Urban Design Memo

To: Andrew Cumberpatch
From: Colin Hattingh
Subject: Resource Consent for the Establishment of the Waikato Regional Theatre Facility
Date: 9 August 2019 File: 010.2018.00010143.001

Figure 2 View from Embassy Park

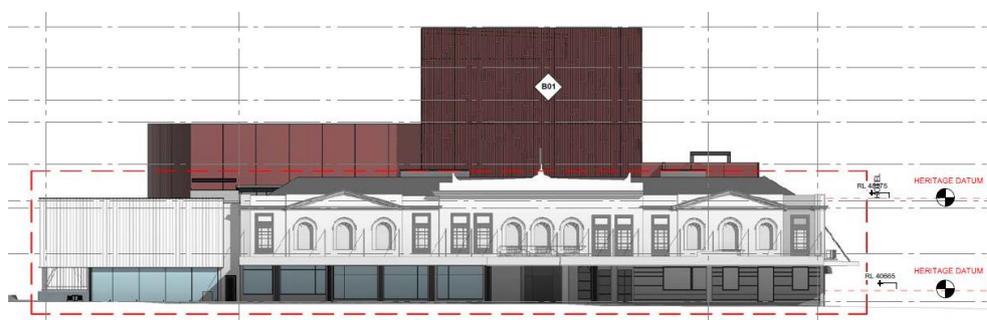
- Engage the community;
 - Build strong physical linkages.
30. The design report contains several images. The following can be highlighted:
